Updated: 8/25/2014 - Tacoma Tire and Loading Information Label Updated

Subject: Non-Compliance Campaign - B0B – Phase 1

Certain 2008 through 2011 Model Year FJ Cruiser, Land Cruiser, Sequoia, Tacoma and Tundra Vehicles Equipped with Toyota-Recommended Light Truck tires and TRD Accessory Wheels

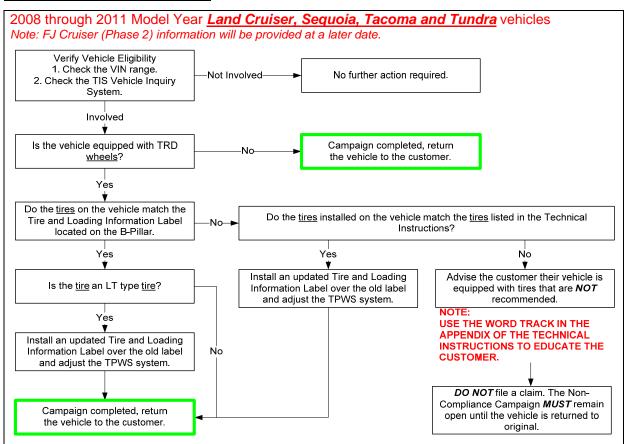
The Tacoma Tire and Loading Information Overlay Label has changed. Please scrap all old labels in dealer inventory and only use the new label below.

Model	Old TRD Label	New TRD Label	Qty	Frequency
Tacoma	00602-35088 00602-35015	00602-35152	5	Weekly
Tundra	00602-0C085	00602-34116	5	Daily
Sequoia	00602-0C085	00602-34116	5	Daily
Land Cruiser	00602-60080	00602-60110	5	Daily
